LINCOLN CITY/LANCASTER COUNTY PLANNING STAFF REPORT

for JUNE 25, 2003 PLANNING COMMISSION MEETING

P.A.S.: Annexation #03002
Change of Zone #3411 from AG and AGR to B-5
Use Permit #150

**Change of Zone #3411
Use Permit #150
S 91st St. & Hwy #2
Appian Way Regional Center**

USE PERMIT SITE PLAN

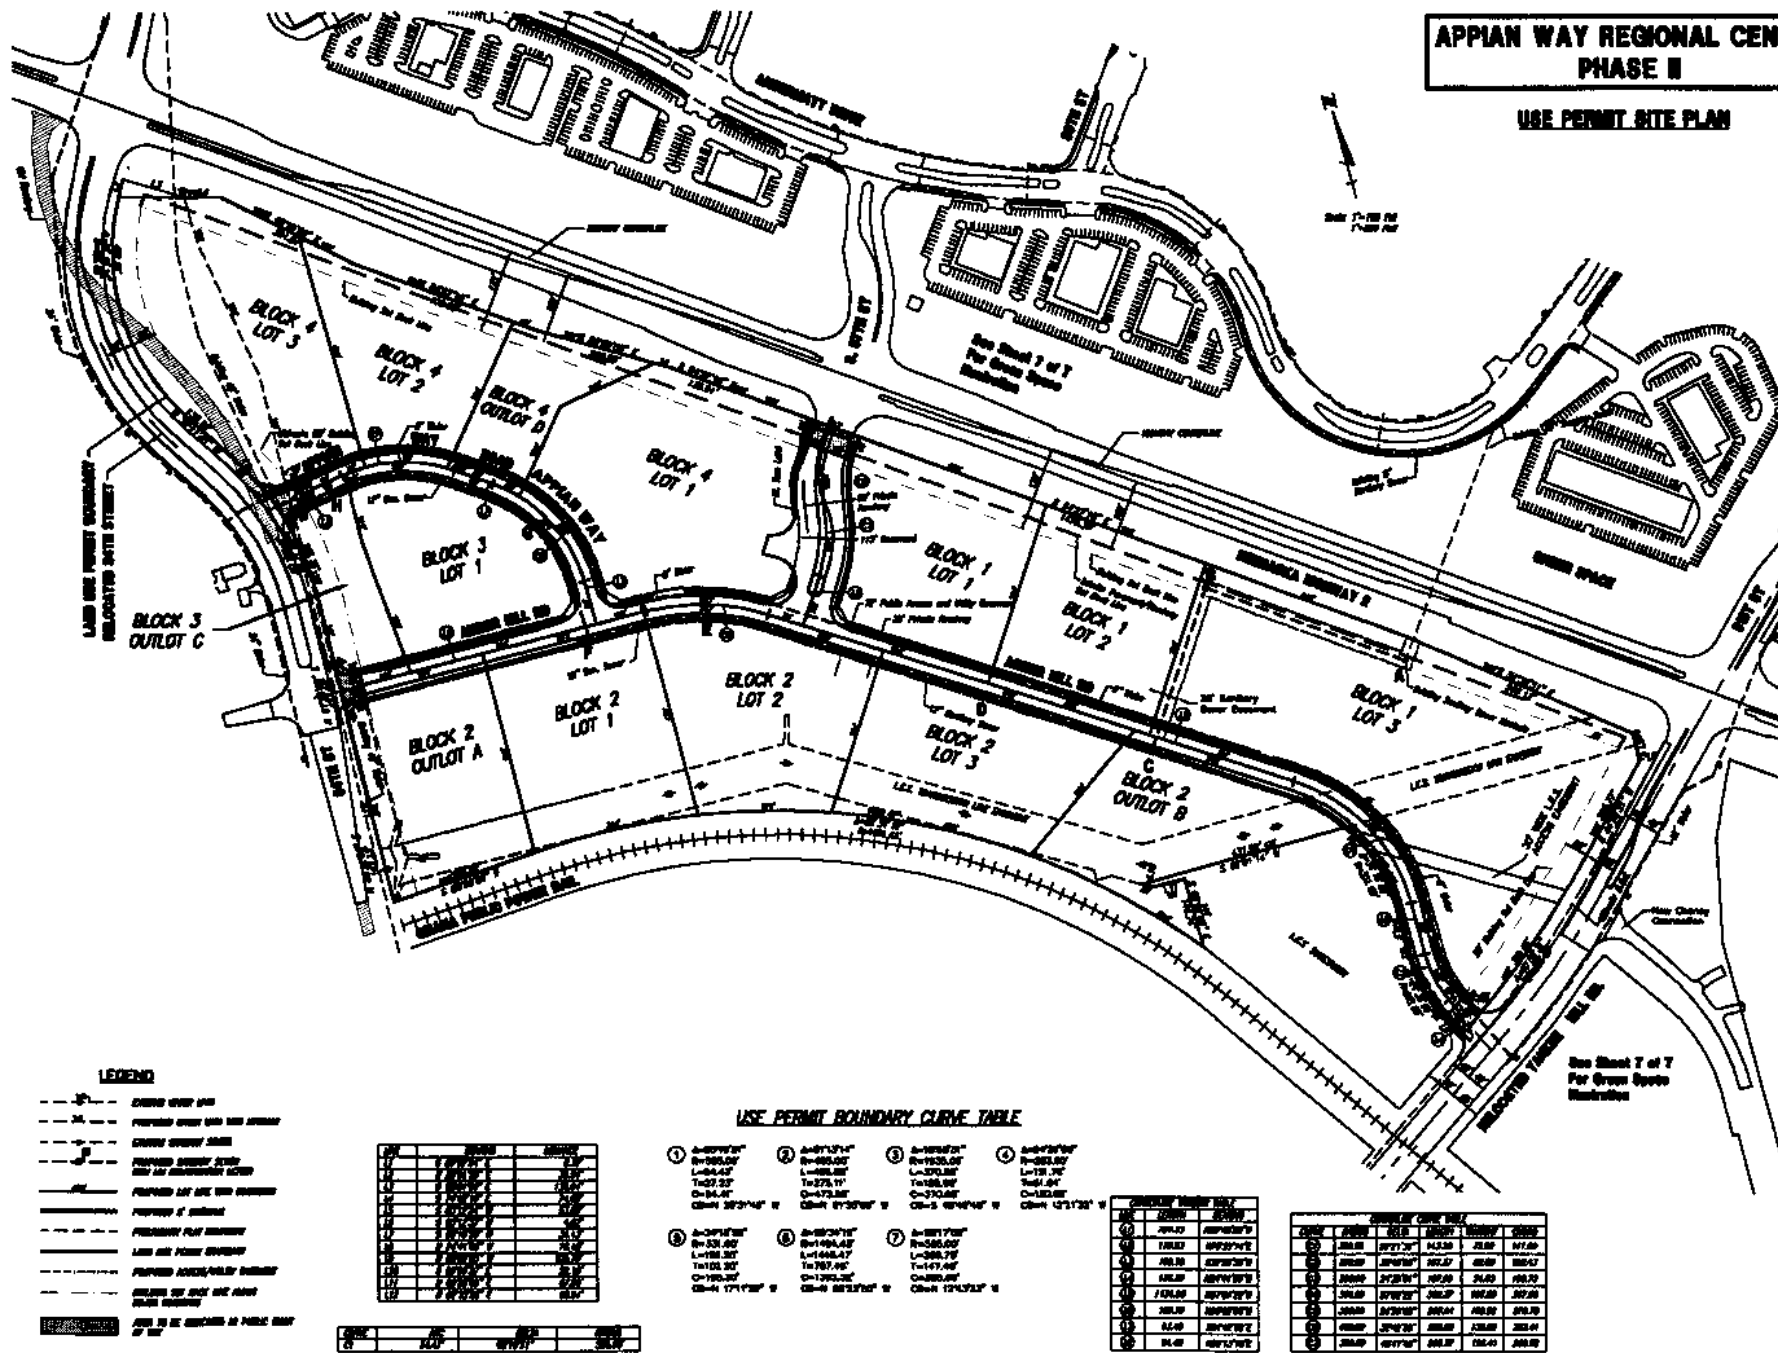
- 1.1 Revise the site plan to show:
 - 1.1.1 An amended Land Use Table showing allowed uses on Lot 3, Block 4, and on Lot 3, Block 1 as office only.
 - 1.1.2 Streets extended 300' beyond the limits of the site plan.
 - 1.1.3 South 84th Street and South 91st Street extended to the southern limit of the plat.
 - 1.1.4 130' wide right-of-way for South 84th Street within 700' of the centerline of Highway 2.
 - 1.1.5 A curb and gutter urban section including left-turn lanes for the full length of South 84th Street.
 - 1.1.6 The right-of-way stub at Appian Way and South 84th Street deleted.
 - 1.1.7 South 91st Street to Amber Hill Road paved with only a right-in/right-out turning movement.

- 1.1.8 The length of the South 87th Street right-of-way stub 80' in length, with a minimum 150'-long dual left-turn lane, and the front yard setback line adjusted accordingly.

- 1.1.9 Sidewalks along the east side of South 84th and the west side of South 91st Streets.
- 1.1.10 A 175' setback to buildings and parking along Highway 2, and a 75' setback to parking and a 100' setback to buildings along both South 84th and South 91st Street. General Note #20 on Sheet 1 of 7 must be revised accordingly.

- 1.1.11 10' wide trail easement along South 84th Street, South 91st Street, and Amber Hill Road.
- 1.1.12 Utility easements required by LES with the notes added to the site plan as noted in the LES June 5, 2003 review.

- 1.1.13 Signed surveyor and engineer certificates.
- 1.1.14 The owners must be shown on the site plan.
- 1.1.15 Note #16 revised to include "the uses in the land use table may be revised by administrative amendment", and deleting "at the time of building permits".

- 1.1.16 The dashed line through the middle of Lot 3, Block 4 on Sheet 1 of 7 labeled.
- 1.1.17 Separate legal descriptions for the AG to B-5 and the AGR to B-5 change of zone request.

**APPIAN WAY REGIONAL CENTER
PHASE II**

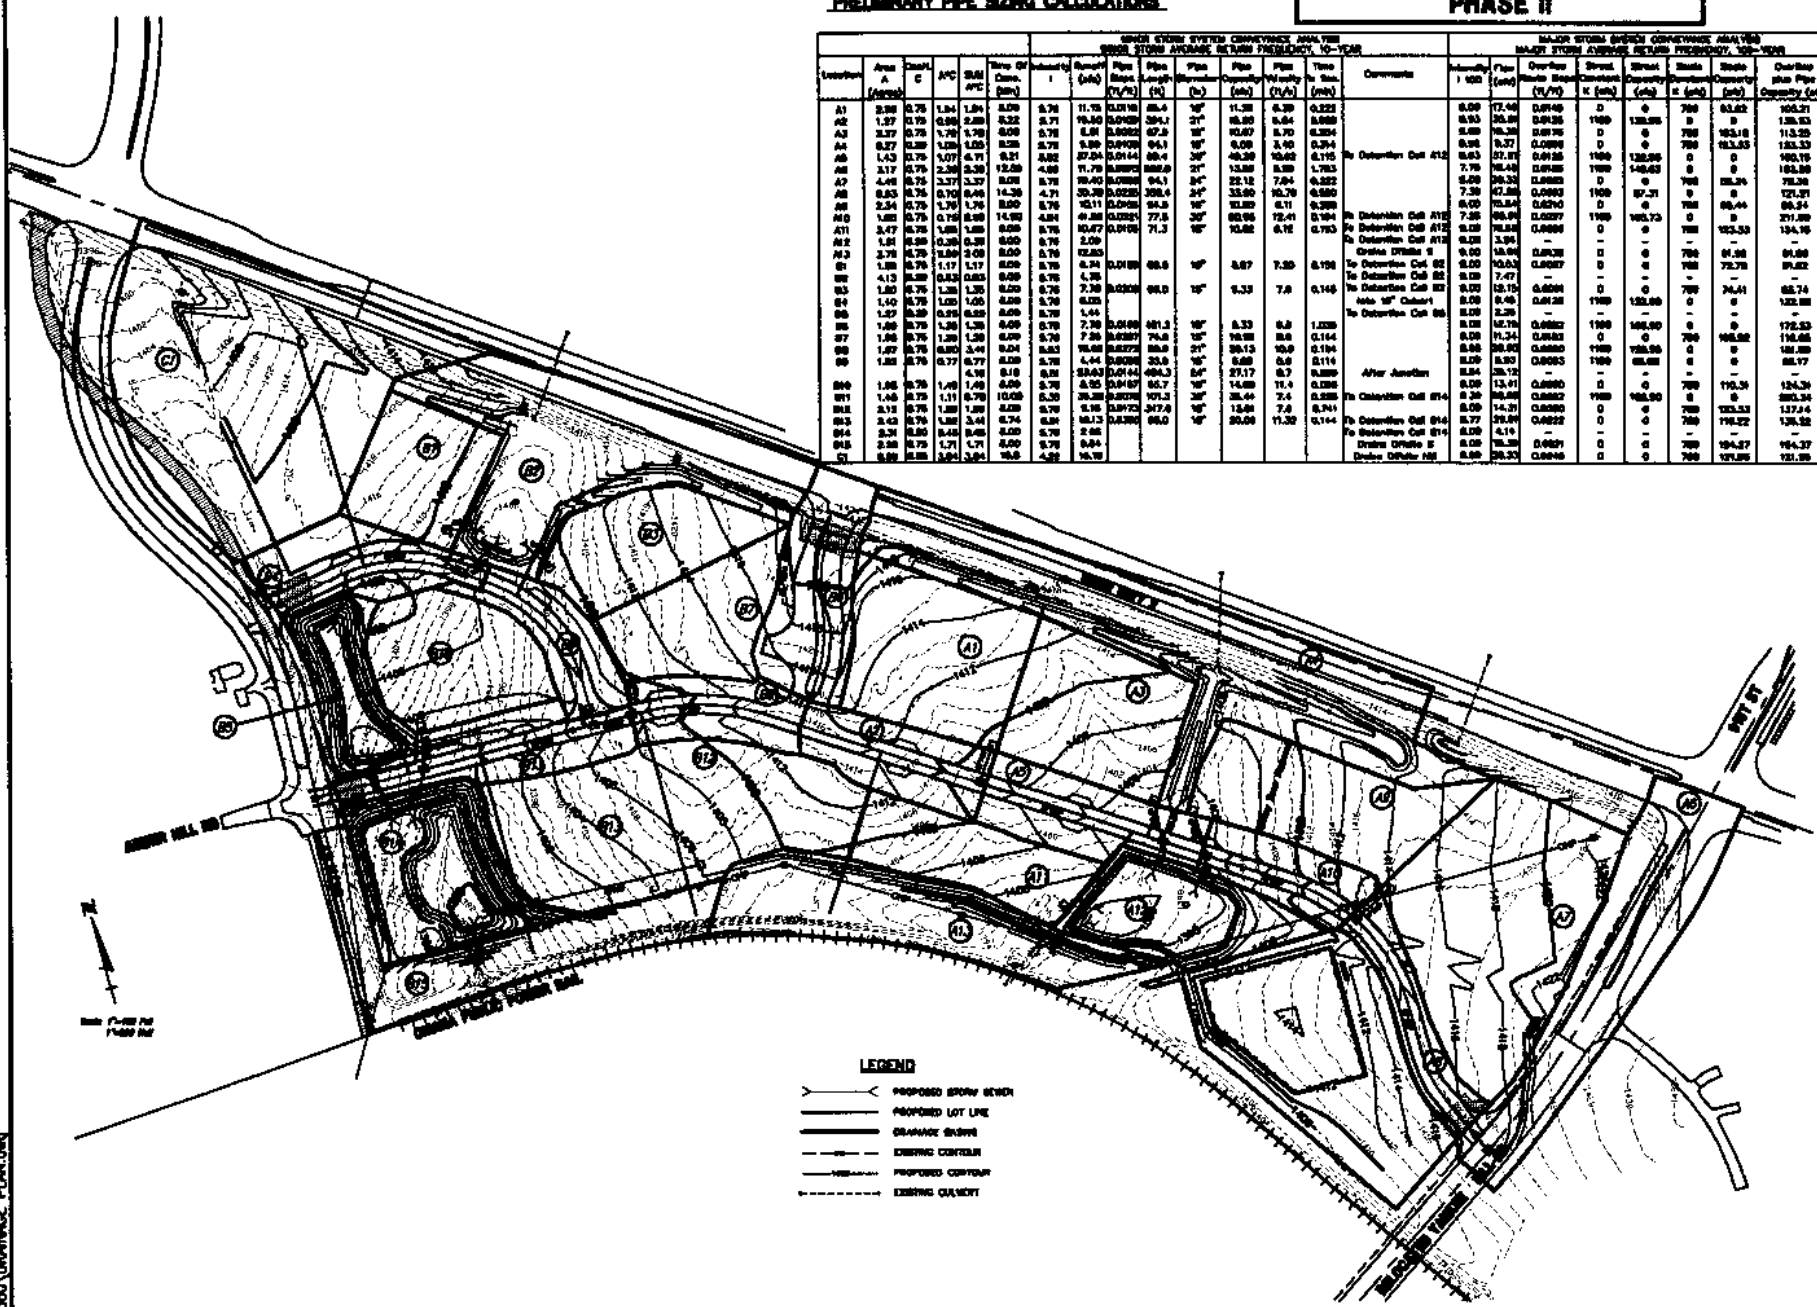
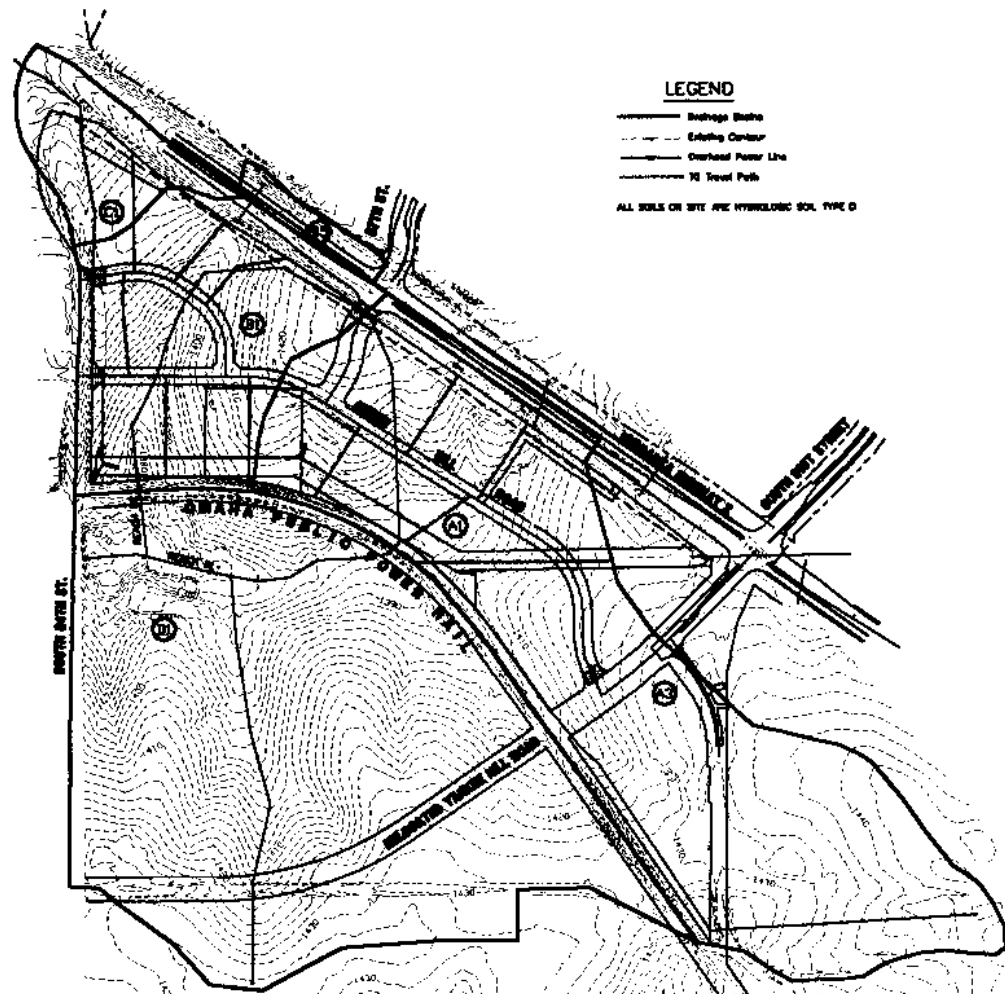
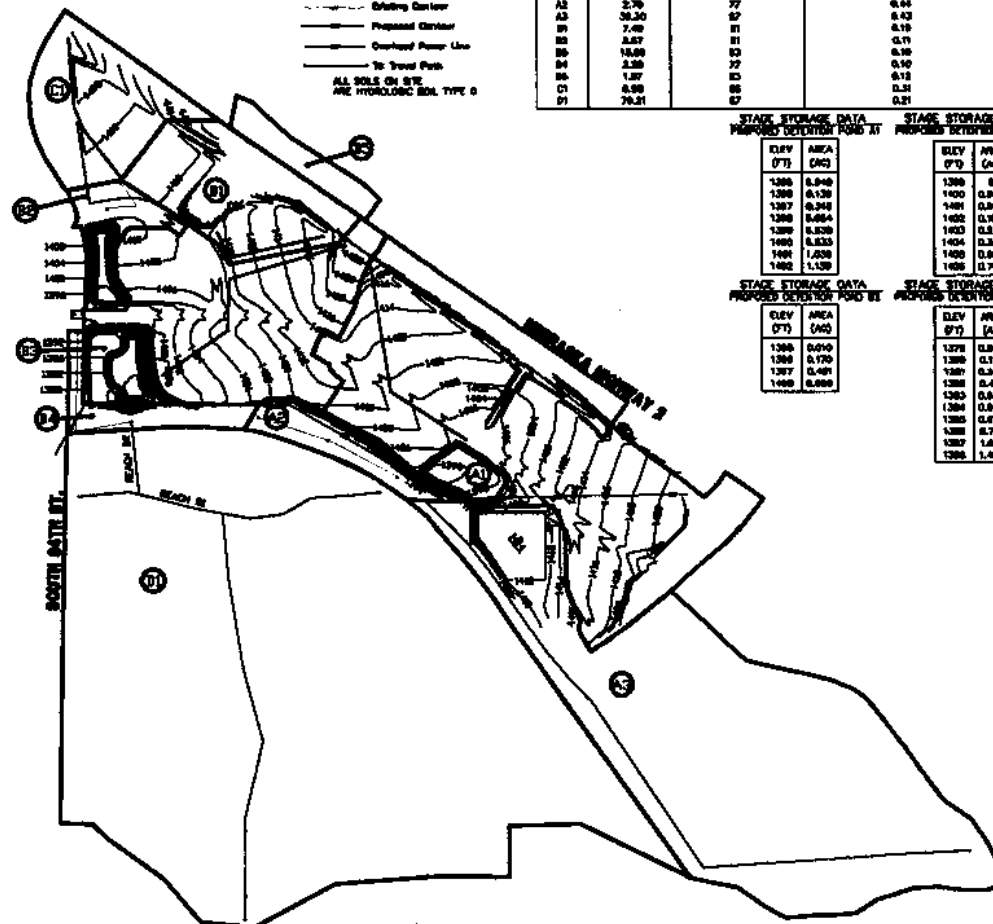
- **Grading/Drainage** - The proposed contours for South 84th Street and for Yankee Hill Road need to be shown on the grading plans.

Show the size and adequacy of the existing culverts in the existing rail road right-of-way.

The inlets into detention cell B3 appear to be outletting onto a platform above the main area of the cell. This platform is less than the required 2% slope. Also, there appears to be an overflow spillway for the platform to the main area of the cell. This overflow area will need some stabilization treatments to prevent erosion on the spillway slope.

Show the offsite area that is drains to the site via the existing culvert shown near the lot line between Lots 2 & 3 of Block 1. This area also needs to be included in the drainage and detention calculations.

Show minimum opening elevations for all lots abutting proposed detention cells and drainage ditches.

5. The post development time of concentration for the drainage area A2 seems to be excessive. The area appears to have a moderate slope and a relatively short flow path

**APPIAN WAY REGIONAL CENTER
PHASE II**

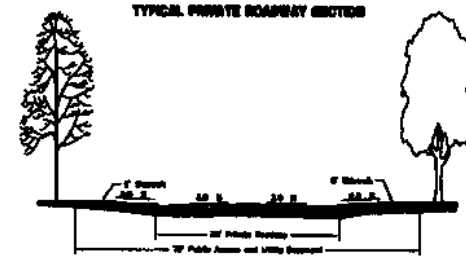
- 1.2 A revised landscape plan that includes street trees along Highway 2 and South 84th Street, and revised to show the type, number and spacing of trees per Design Standards. All landscaping must be shown on private property.
